UNITED STATES PATENT AND TRADEMARK OFFICE

APPLICATION NO.	FILING DATE	FIRST NAMED INVENTOR	ATTORNEY DOCKET NO.	CONFIRMATION NO.
10/782,966	02/23/2004	Shinya Marushima	NIP-149-05	7565

Office Action Summary	Application No. 10/782,966	Applicant(s) MARUSHIMA ET AL. ED	
	Examiner William H. Rodriguez	Art Unit 3746

DETAILED ACTION***Drawings***

Fig. 4C**Figures 4A, 4C of Carreno.**

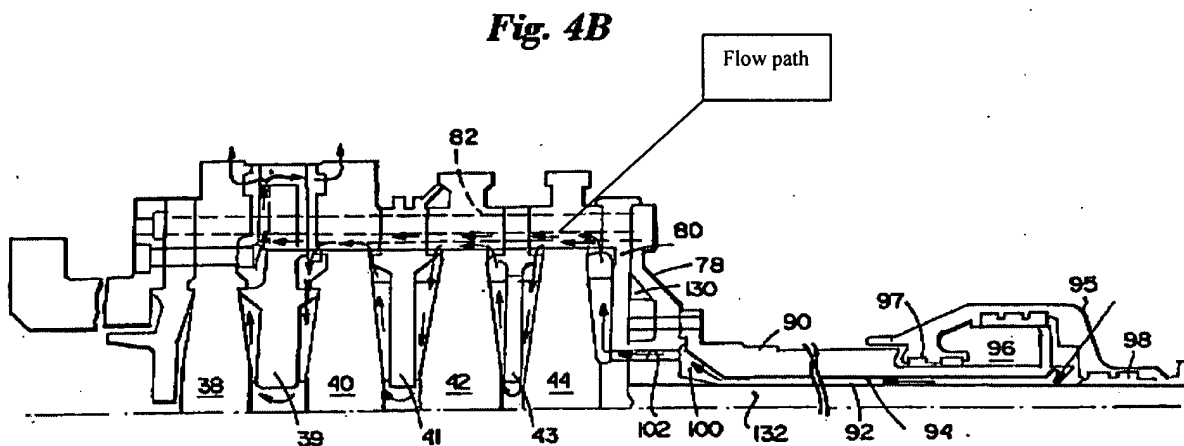
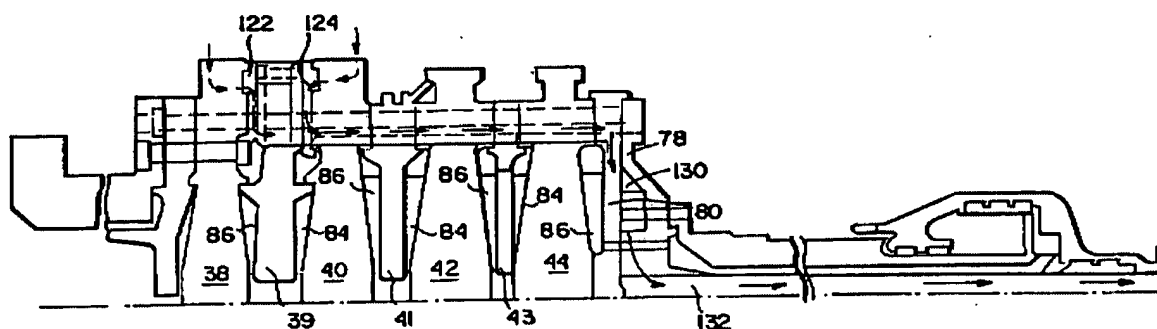
4. Claims 11 and 12 are rejected under 35 U.S.C. 103(a) as being unpatentable over Carreno et al. (U.S. 5,593,274) in view of Suenaga et al. (U.S. 5,795,130).

With respect to claim 11, **Carreno** teaches a gas turbine which a rotor shaft comprises a plurality of discs 38, 40, 42, 44 each having a plurality of moving blades arranged annularly on the peripheral portion, and spacers 39, 41, 43 arranged between said discs, said respective discs 38, 40, 42, 44 and spacers being arranged in an axial direction in turn, comprising: gap portions 84, 86 formed between rotor axis side regions of said discs 38, 40, 42, 44 facing said spacers 39, 41, 43 and adjacent spacers; a supply flow path 92 for supplying refrigerant for cooling to said moving blades and a recovery flow path 132 for recovering heated refrigerant, each of said supply and recovery flow paths being provided in said rotor shaft; a flow path (see Figure 4B) for introducing fluid into said gap portions 84, 86 provided in said discs (see particularly **Figures 4B, 4C** of **Carreno** above). **Carreno** does not schematically show that the recovery flow path is arranged on a more radially outer side than said supply flow path but said recovery flow path 132 is arranged on a more radially inner side than said supply flow path 92. However, **Suenaga** teaches a typical heat recovery type gas turbine similar to **Carreno's** heat recovery type gas

FIG. 25
PRIOR ART

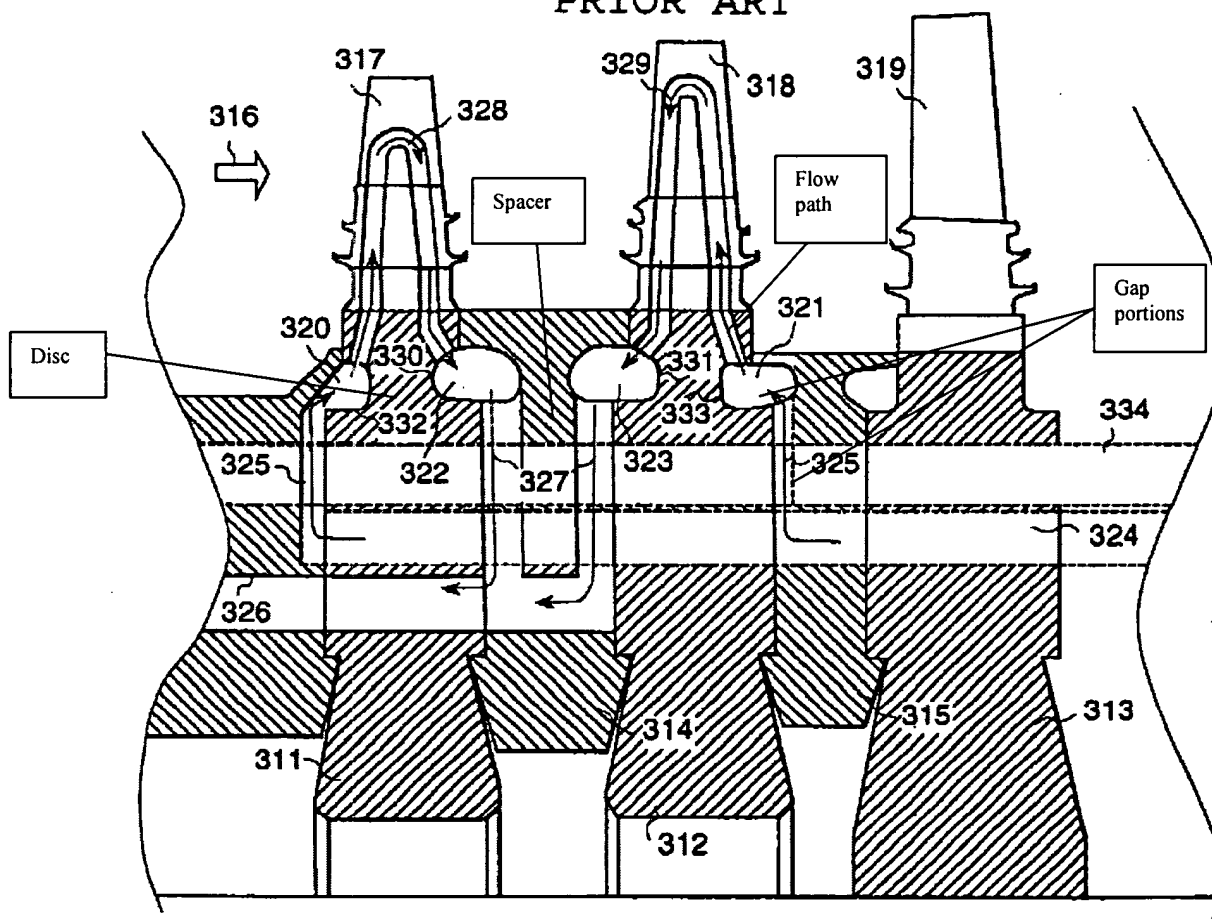
5. Claims 11-13 are rejected under 35 U.S.C. 103(a) as being unpatentable over **Akiyama et al.** (U.S. 6,334,756) in view of **Suenaga et al.**(U.S. 5,795,130).

With respect to claim 11, **Akiyama** teaches a gas turbine which a rotor shaft comprises a plurality of discs each having a plurality of moving blades arranged annularly on the peripheral portion, and spacers arranged between said discs, said respective discs and spacers being arranged in an axial direction in turn, comprising: gap portions formed between rotor axis side

regions of said discs facing said spacers and adjacent spacers; a supply flow path 324 for supplying refrigerant for cooling to said moving blades and a recovery flow path 326 for recovering heated refrigerant, each of said supply and recovery flow paths being provided in said rotor shaft; a flow path for introducing fluid into said gap portions provided in said discs (see particularly **Figure 25** of **Akiyama** above). **Akiyama** does not schematically show that the recovery flow path is arranged on a more radially outer side than said supply flow path but said recovery flow path 326 is arranged on a more radially inner side than said supply flow path 324. However, **Suenaga** teaches a typical heat recovery type gas turbine similar to **Akiyama's** heat recovery type gas turbine, wherein the recovery flow path 11 is arranged on a more radially outer side than said supply flow path 11. Accordingly, it would have been prima facie obvious to one of ordinary skill in the art at the time the invention was made to have modified **Akiyama** (as taught by **Suenaga**) such that the recovery flow path is arranged on a more radially outer side than said supply flow path because such a modification would have not affected the efficient operation of **Akiyama's** gas turbine and further such modification would have been considered a mere design consideration which fails to patentably distinguish over **Akiyama**. See particularly **Figure 1** of **Suenaga**.

With respect to claim 12, **Akiyama** teaches a gas turbine which a rotor shaft comprises a plurality of discs each having a plurality of moving blades arranged annularly on the peripheral portion, and spacers arranged between said discs, said respective discs and spacers being arranged in an axial direction in turn, comprising: gap portions formed between rotor axis side regions of said discs facing said spacers and adjacent spacers; a supply flow path 324 for

supplying steam for cooling to said moving blades and a recovery flow path 326 for recovering heated steam, each of said supply and recovery flow paths being provided in said rotor shaft; a flow path for introducing fluid into said gap portions provided in said discs (see particularly **Figure 25**; and column 5 lines 40-46 of **Akiyama**). **Akiyama** does not schematically show that the recovery flow path is arranged on a more radially outer side than said supply flow path but said recovery flow path 326 is arranged on a more radially inner side than said supply flow path 324. However, **Suenaga** teaches a typical heat recovery type gas turbine similar to **Akiyama**'s heat recovery type gas turbine, wherein the recovery flow path 11 is arranged on a more radially outer side than said supply flow path 11. Accordingly, it would have been prima facie obvious to one of ordinary skill in the art at the time the invention was made to have modified **Akiyama** (as taught by **Suenaga**) such that the recovery flow path is arranged on a more radially outer side than said supply flow path because such a modification would have not affected the efficient operation of **Akiyama**'s gas turbine and further such modification would have been considered a mere design consideration which fails to patentably distinguish over **Akiyama**. See particularly **Figure 1** of **Suenaga**.

With respect to claim 13, **Akiyama** teaches a gas turbine which a rotor shaft comprises a plurality of discs each having a plurality of moving blades arranged annularly on the peripheral portion, and spacers arranged between said discs, said respective discs and spacers being arranged in an axial direction in turn, comprising: gap portions formed between rotor axis side regions of said discs facing said spacers and adjacent spacers; a supply flow path 324 for supplying steam for cooling to said moving blades and a recovery flow path 326 for recovering

heated steam, each of said supply and recovery flow paths being provided in said rotor shaft; a flow path for introducing fluid into said gap portions provided in said discs; wherein said flow path for introducing fluid into said gap portion is constructed so as to be supplied with air extracted from a compressor (see particularly **Figure 25**; and column 5 lines 40-46 of **Akiyama**). **Akiyama** does not schematically show that the recovery flow path is arranged on a more radially outer side than said supply flow path but said recovery flow path 326 is arranged on a more radially inner side than said supply flow path 324. However, **Suenaga** teaches a typical heat recovery type gas turbine similar to **Akiyama**'s heat recovery type gas turbine, wherein the recovery flow path 11 is arranged on a more radially outer side than said supply flow path 11. Accordingly, it would have been prima facie obvious to one of ordinary skill in the art at the time the invention was made to have modified **Akiyama** (as taught by **Suenaga**) such that the recovery flow path is arranged on a more radially outer side than said supply flow path because such a modification would have not affected the efficient operation of **Akiyama**'s gas turbine and further such modification would have been considered a mere design consideration which fails to patentably distinguish over **Akiyama**. See particularly **Figure 1** of **Suenaga**.

Note that **Akiyama** (column 5 lines 40-46) teaches using a combination of air and steam for cooling, just as claimed by the invention in claim 13.
